City of Findlay City Planning Commission

Thursday, April 11, 2013 - 9:00 AM

COMMENTS

FINAL PLAT #FP-01-2013
REPLAT OF LOT 3 EASTERN WOODS SUBDIVISION

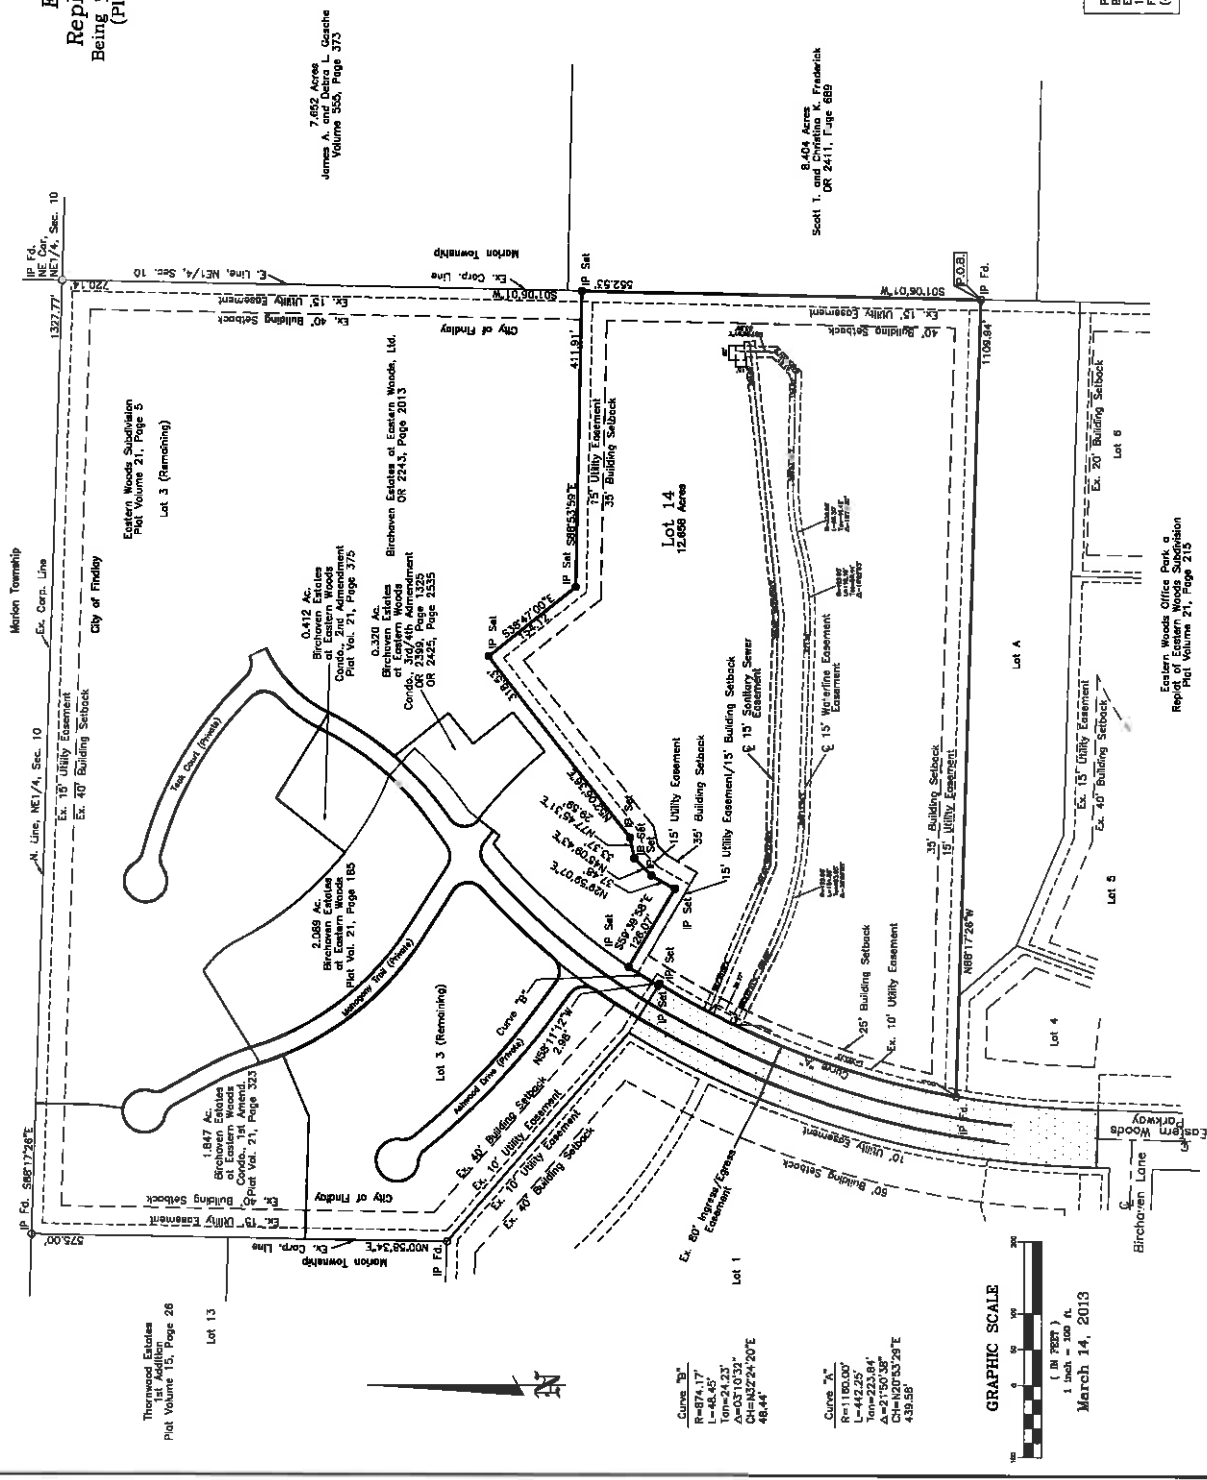
Item #3 on today's agenda is a site plan for an apartment complex to be constructed on the proposed Lot 14 of this replat. In the review process for the site plan, we noted that the lot coverage for impervious surface in the M-2 district is exceeded. A suggestion at this point would be the possible reconfiguring of Lot 14 to include more acreage to make the site plan work

Staff recommends that FCPC approve the Replat of Lot 3 in the Eastern Woods Subdivision.

FINAL PLAT #FP-02-2013
REPLAT OF LOT 2 OF THE INTERSTATE WEST
SUBDIVISION

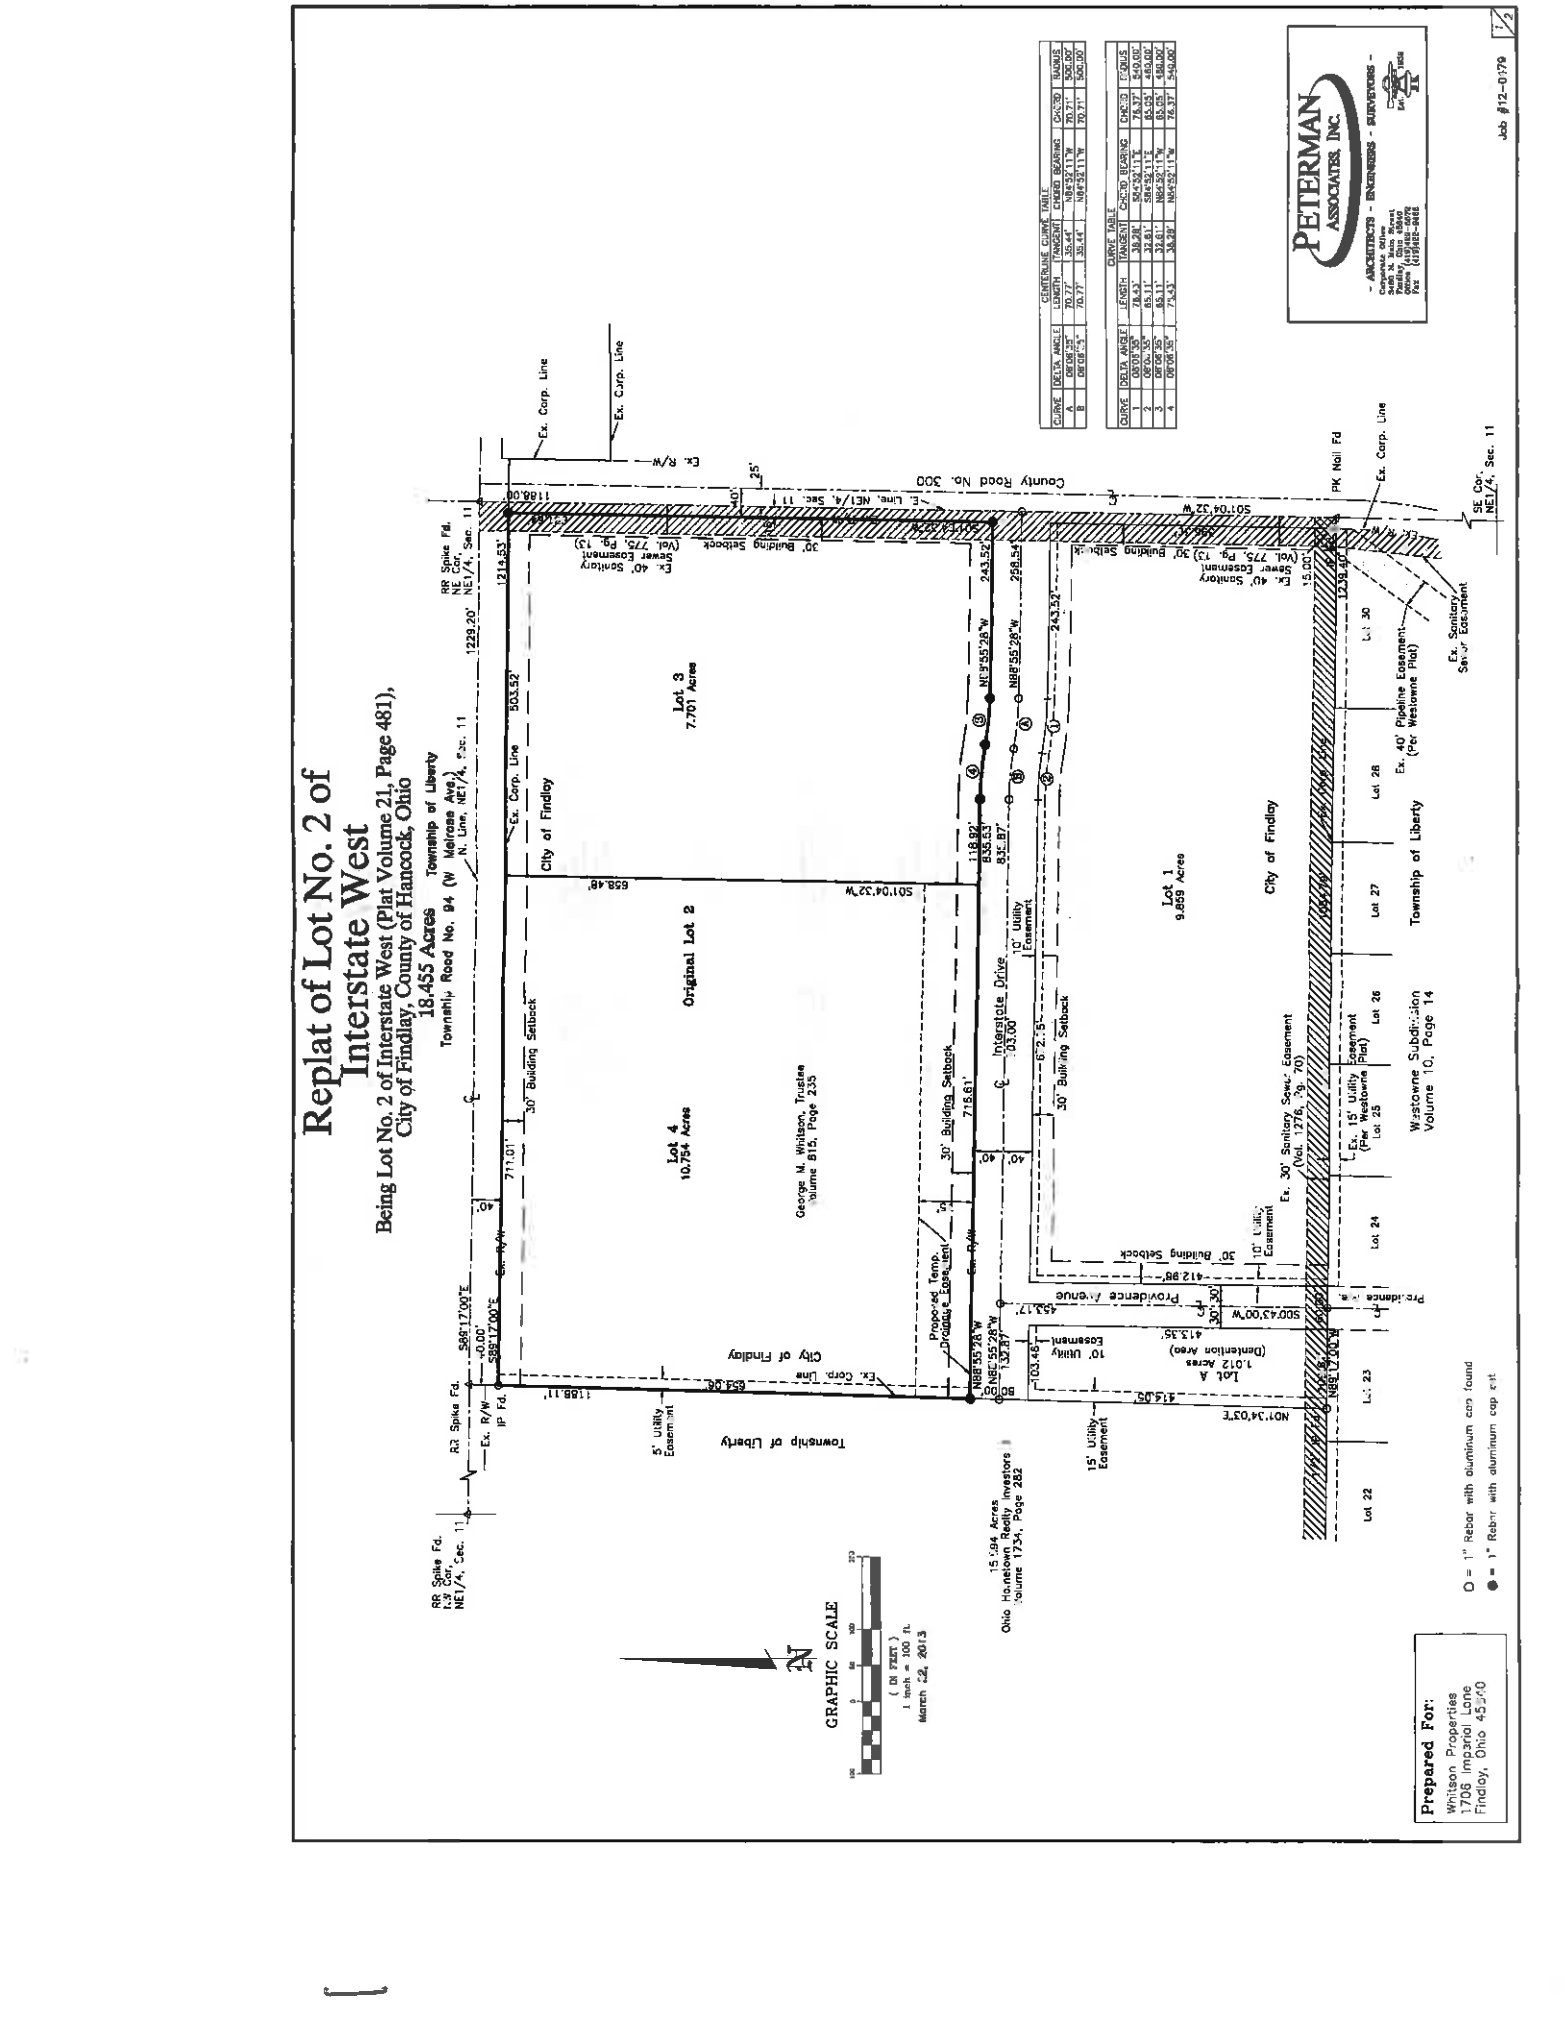
Drainage easement along south side of Lot 4 is shown as temporary. Spoke with T. Jenkins of Peterman Associates regarding this. He stated that the drainage easement is listed as temporary because the intent is that the large swale area would go away once the parcels are developed and that a more defined easement over a storm sewer would be provided.

Staff recommends that FCPC approve the Replat of Lot #2 of Interstate West Subdivision.

Rezoning Exhibit for
Dietsch Brothers
400 W. Main Cross

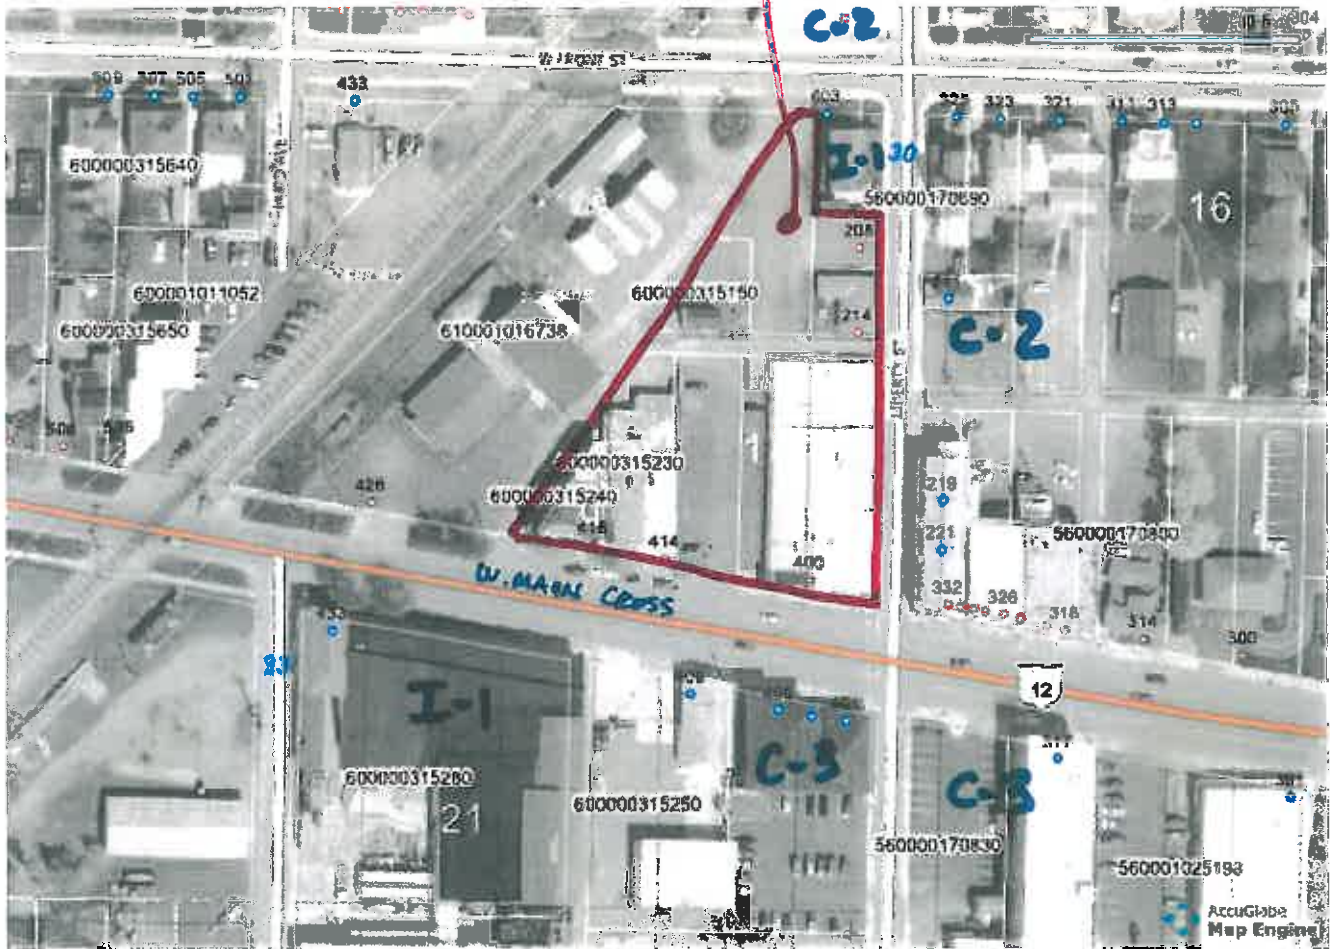
There is a companion site plan next on the agenda for a proposed expansion of the Dietsch Brothers business. The request is in conformance with the City Land Use Plan.

Staff recommends that FCPC recommend approval to Findlay City Council of **PETITION FOR ZONING AMENDMENT #ZA-03-2013** to rezone 400, 414, & 418 W. Main Cross St., 208 & 214 Liberty Street, Findlay, OH from I-1 Light Industrial to C-3 Downtown Commercial.

OVERALL PROPOSED SITE PLAN

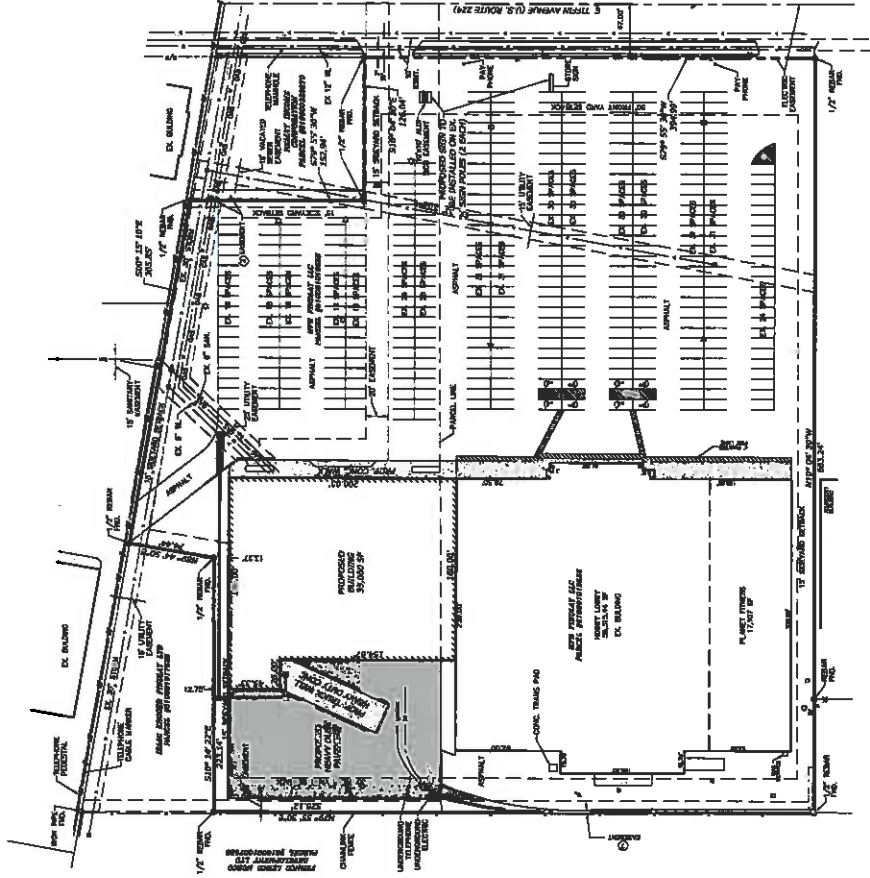
The front line of the new store will follow the front line of the Hobby Lobby. The west side will be connected to that store. The east side of the building is shown at only 12.75 feet from the property line. The minimum side yard is 15'. If the 15' cannot be achieved, a variance will need to be sought from the BZA. The tight spacing here may also be detrimental to access for safety services. The other stores in the strip access the rear of their buildings from the west side so perhaps an access agreement from those properties would work.

Two sign locations are indicated on the plan. The location indicated as the "10' x 10' Aldi Sign Easement" may have an existing pole still in place. However, once the sign cabinet was removed, the location was no longer legal for a new sign. If the old cabinet was still in place the face could have been changed out for a new user. Since that is gone, the use of that non-conforming sign is gone. A site such as this that has multiple tenants sharing access and parking is permitted one pylon sign. The second location indicated on the plan for a sign is the existing Hobby Lobby/Planet Fitness pylon. The new business can co-locate a sign on this pole. The size permitted will be determined by the square footage already in use by the other businesses. The code allows for lots with more than 100' of road frontage to have ½ square foot of sign face per lineal feet of frontage. In this case the frontage is 395 which allows for a total of 197.5 square feet of total sign face.

The maximum height in the C-2 district is 60 feet. The plans show the height of the building to be 43'-4". Because the north end of the building abuts a residential use (Chateau East mobile home park), screening will be required on this border. The lot for the Dick's store is about 200'

Access – Access to the site would remain unchanged. Access around the building will be impeded. Recommend easement of access acquired from adjacent property or building width reduced to allow for emergency vehicle and truck circulation and eliminate need for side yard variance.

Water – New service will be connected to existing tap. The site plan does not identify if a separate line for fire protection will be installed.

Stormwater Management – Detention calculations will be required due to increase in impervious area.

- Provide access drive on the east side of the structure for deliveries and FFD trucks.
- Provide fire hydrant within 100' of the Fire Department Connection (FDC). Hydrant shall not be placed on the designated fire line and be supplied by a minimum of a 6" water main if looped. Water main shall be at least 8" if the water main is not looped (dead end).

- A Knox Box shall be required for buildings with sprinkler and/or fire alarm systems.
- Hobby Lobby has 2 existing emergency exit doors on the eastern wall for direct exterior access. If adjoining this existing structure, how will the emergency exits be addressed?

1. Rectification of the east setback either by reduction in building or variance obtained from BZA (HRPC & ENG)
2. Screening along north side of property (HRPC)

3. Elimination of second sign as indicated (HRPC)
4. Approval of a landscaping plan (HRPC)
5. Approval of detention calculations due to increase in impervious area. (ENG)

6. Approved Stormwater Pollution Prevention Plan (ENG)
7. Provide access drive on the east side of the structure for deliveries and FFD trucks. (FIRE)
8. Provide fire hydrant within 100' of the Fire Department Connection (FDC). Hydrant shall not be placed on the designated fire line and be supplied by a minimum of a 6" water main if looped. Water main shall be at least 8" if the water main is not looped (dead end). (FIRE)

14. Hobby Lobby has 2 existing emergency exit doors on the eastern wall for direct exterior access. If adjoining this existing structure, how will the emergency exits be addressed? (FIRE)
